Issuing Entity: Wadkins Expo Wheel, Inc. 11501 Sherwood Road Upper Falls, Maryland 21156 443-463-8016 443-463-1637 wadkinsexpowheel@yahoo.com	Bulletin No.: 2013-1
		Release Date: January 3, 2014
		Effective Date: January 3, 2014
		Supersedes: N/A
		Completion Date: Immediate testing to be completed before resuming public operation
		Page: 1 of 5

SAFETY ALERT

Ride Manufacturer: Wadkins Expo Wheel, Inc. Expo Wheels, LLC Childress Manufacturing	Affected Production Dates: 1996-2009
Ride Name: Expo Wheel	Affected Serial Nos.: All before 2010
Model Number: All with bronze-bushing axles	
<p>Abstract Of Issue: All Expo Wheels with original bronze-bushing axles must be ultrasonic tested. Cracks may occur next to welds behind flange or behind the 8 bolts on main axle.</p> <p>Reason For Release: Wadkins Expo Wheel, Inc., has been made aware of an Expo Wheel on which the axle has cracked. The effect may occur in or out of plain sight. If this occurs, do not operate the Expo Wheel.</p> <p>WARNING: FAILURE TO COMPLY WITH SAFETY ALERT CAN RESULT IN INJURY TO PASSENGERS OR OPERATORS.</p> <p>Wadkins Expo Wheel, Inc., issues notifications for the benefit of owners of amusement rides manufactured b

Diagram 1 –

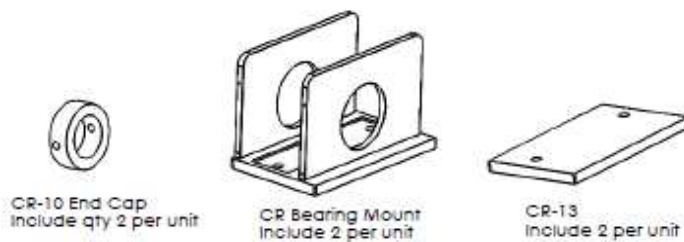
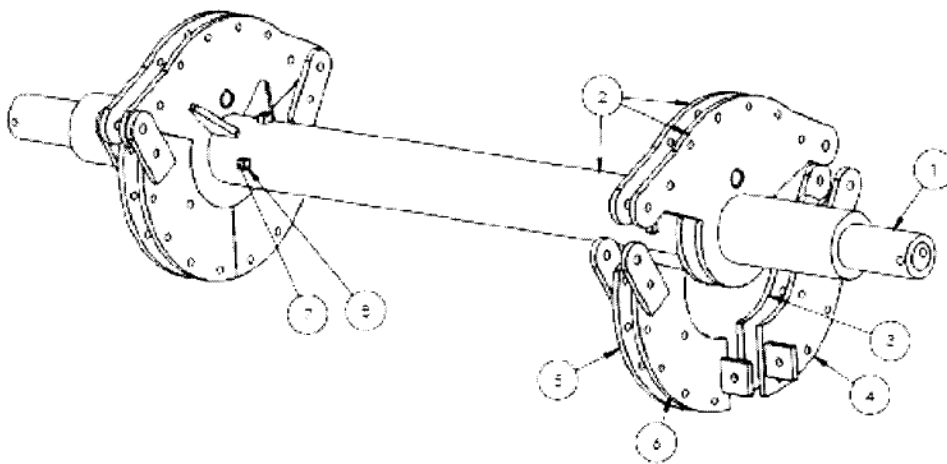
Each Expo Wheel with an original bronze-bushing axle must have the entire axle ultrasonic tested immediately by an outside, licensed firm. The main axle is identified as Item No. 1 in Diagram 1.

Diagram 2 –

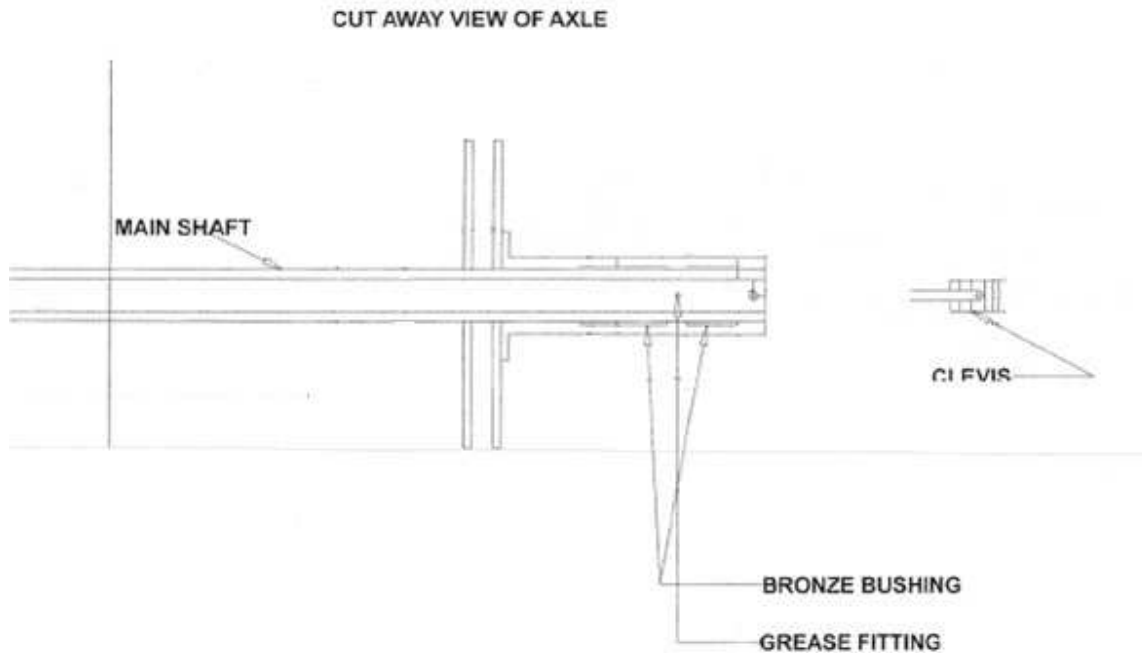
Diagram 2 shows the location of the bronze bushings.

Diagram 3 –

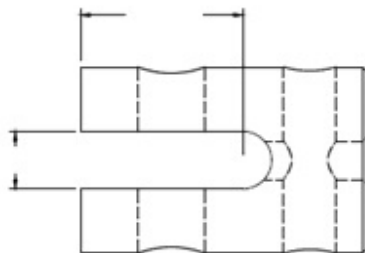
If the axle *passes* the ultrasonic testing, install a safety cable through the center of the axle. Attachment of the clevis cable is shown in diagram 3.

Diagram 4 –

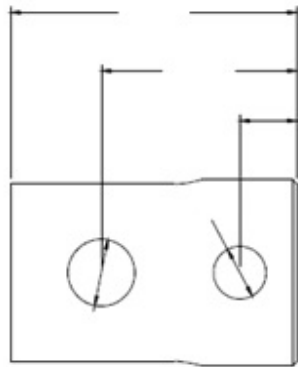
Clevis pin material is shown in diagram 4.
